HARTING Product Change Notification

PCN/20/013/PM+MD

Title: M12 PCB receptacles D-coded angled one-piece contacts - External

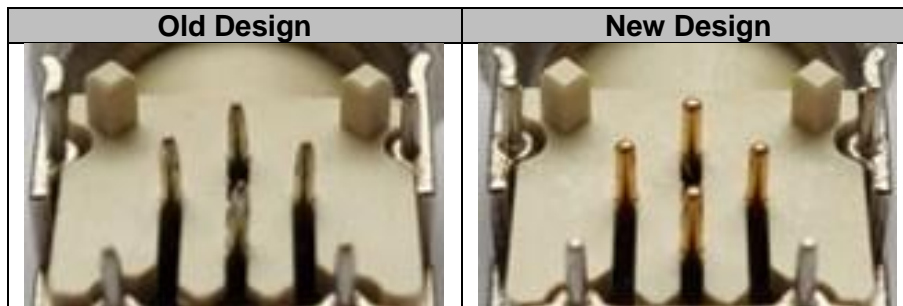
Today a 2-piece contact will be used in angled D-coded M12 PCB receptacles. This 2-piece contact will be replaced by 1-piece contacts in future. This change will be performed in order to achieve a more stable and reliable manufacturing process. The change is visible by gold plated contact while old contact had a nickel plating.

This change has no impact on the product specification and no influence on applications, as footprint of the M12 PCB receptacle remains unchanged.
